PLANS AND DOCUMENTS
referred to in the PDA
DEVELOPMENT APPROVAL

Approval no: DEV2023/1383
Date: 23 August 2023

Site Based Stormwater Management Plan and Engineering Services Report

HPG Oxley Retirement Living

Functional Layout
EARTHWORKS PLAN
SECTIONS

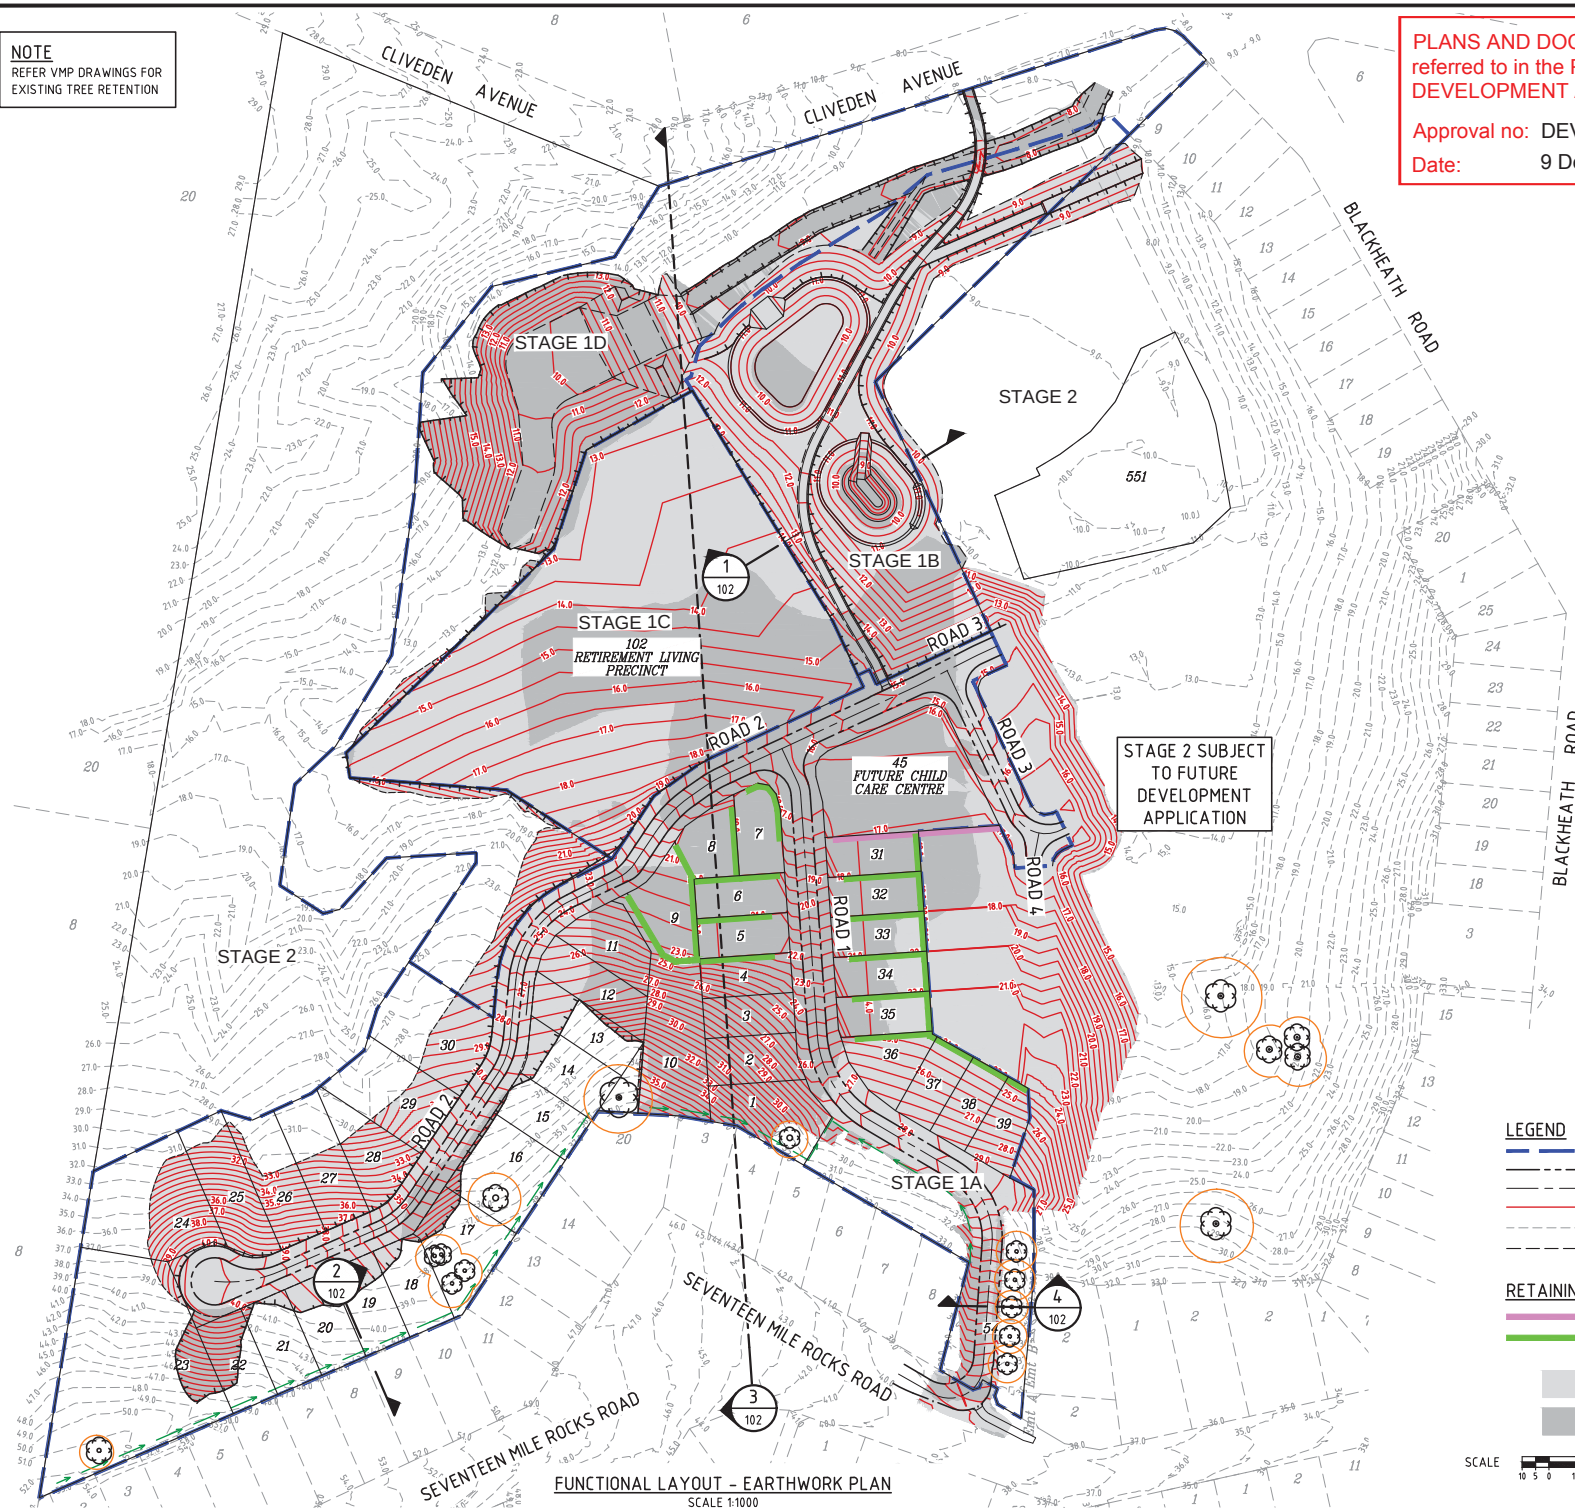
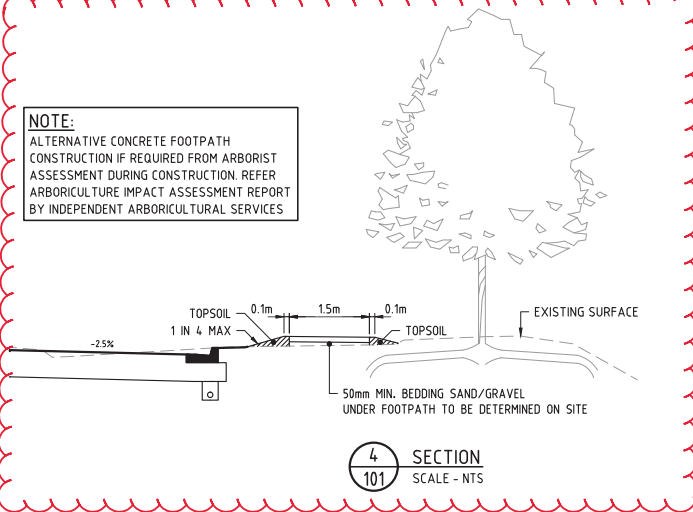
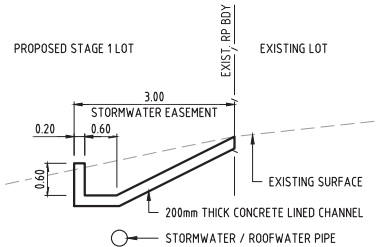
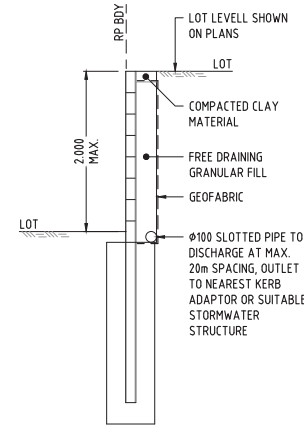
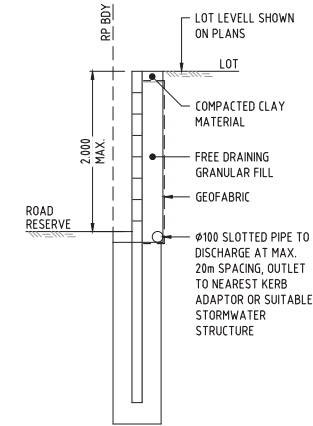
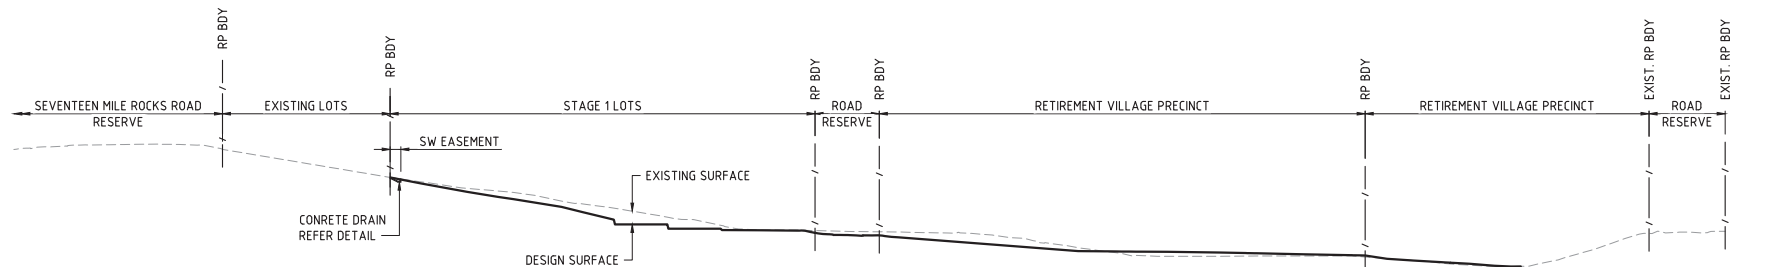
Amend in accordance with design
endorsed by Compliance Assessment
Condition 18

Drawing title
**FUNCTIONAL LAYOUT
STORMWATER**

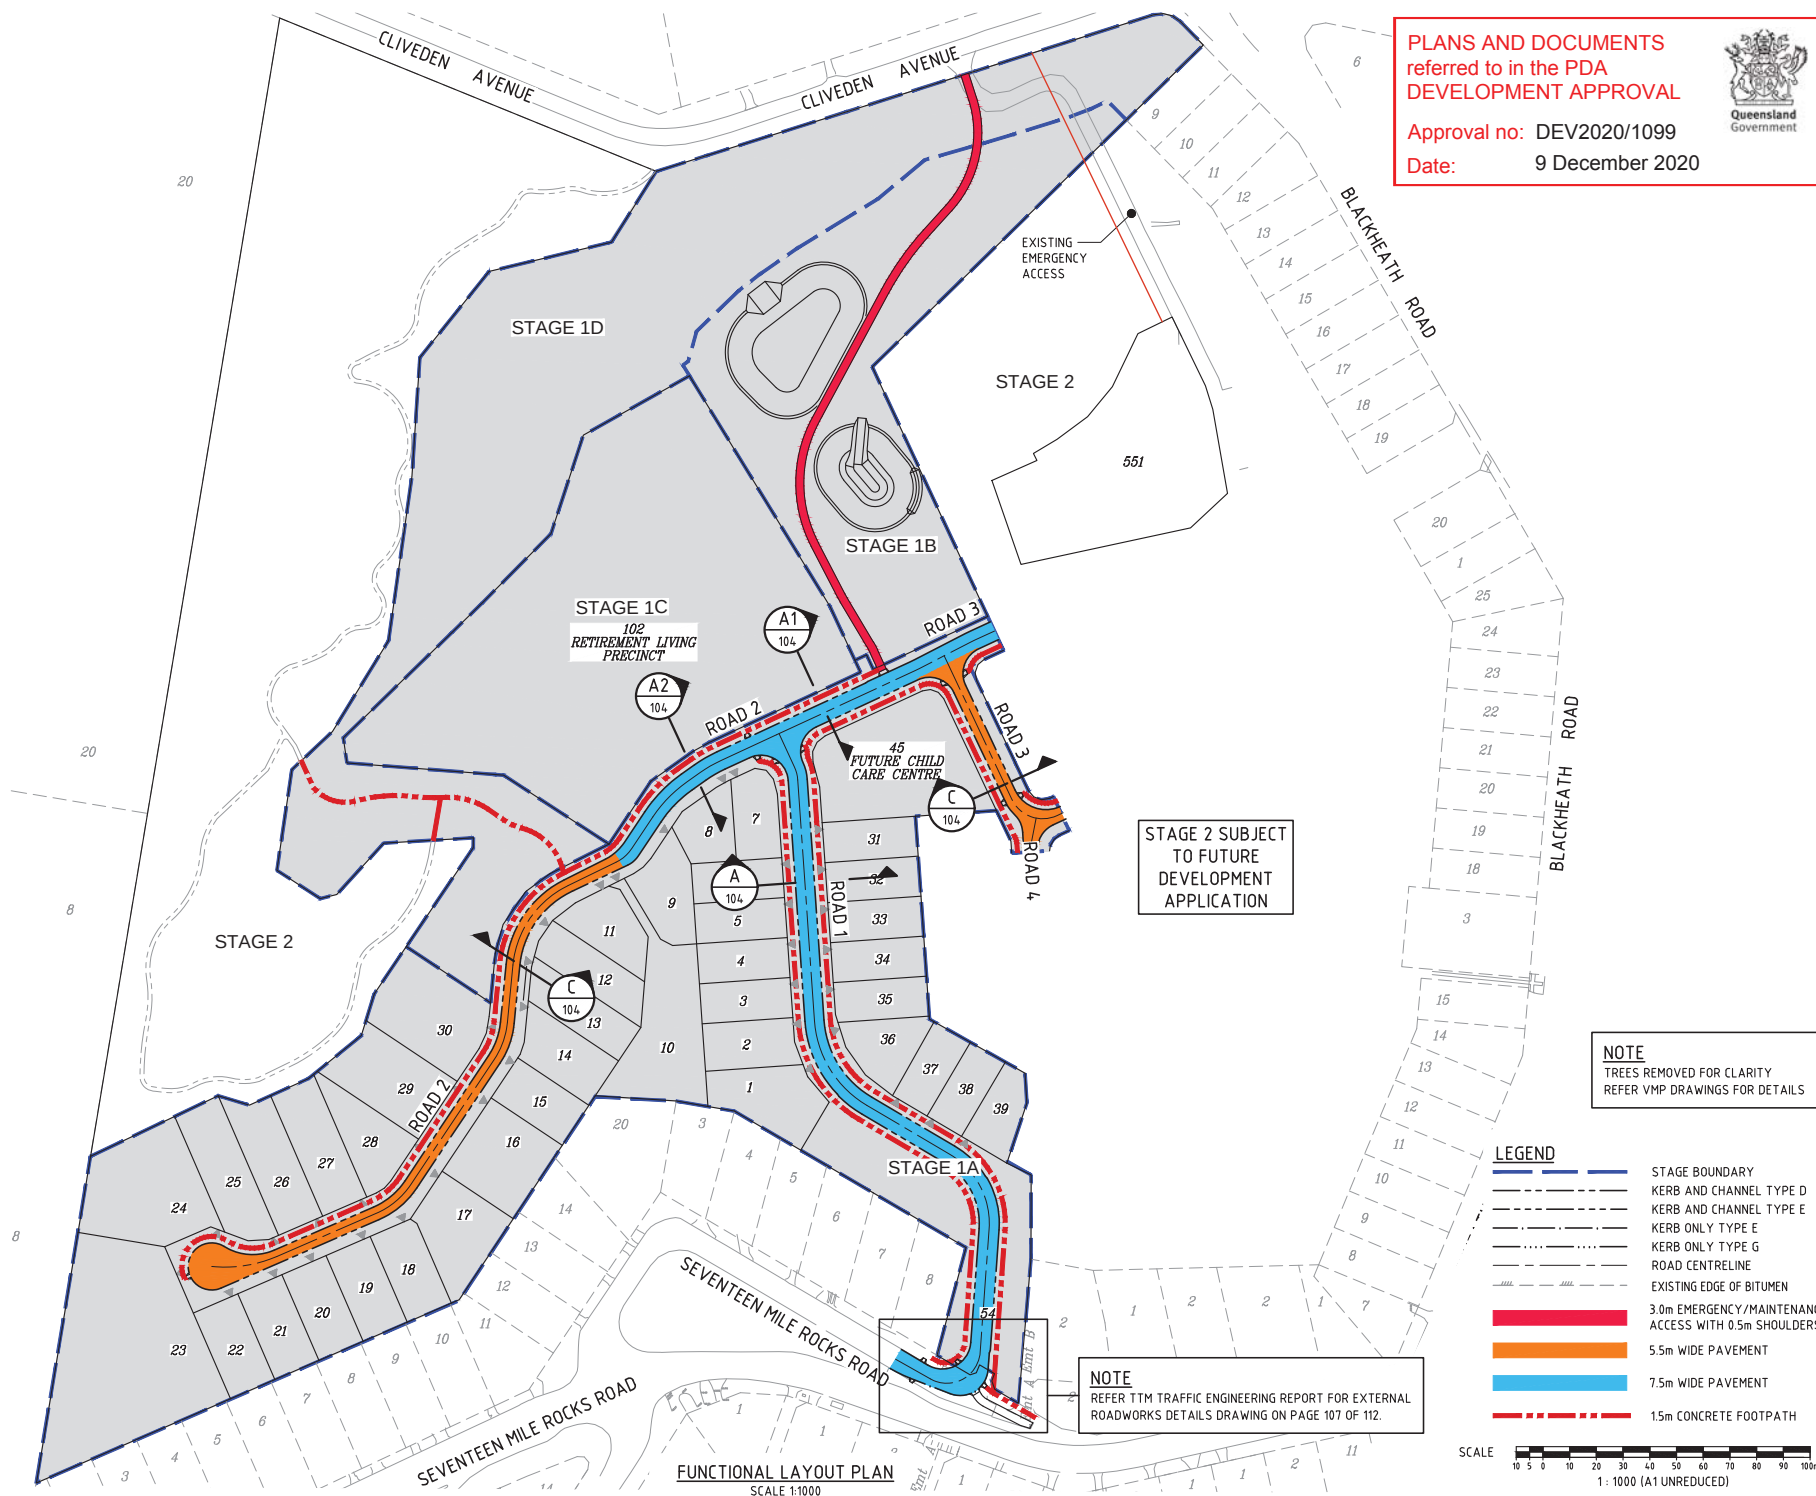
Amend in accordance with
Condition 21
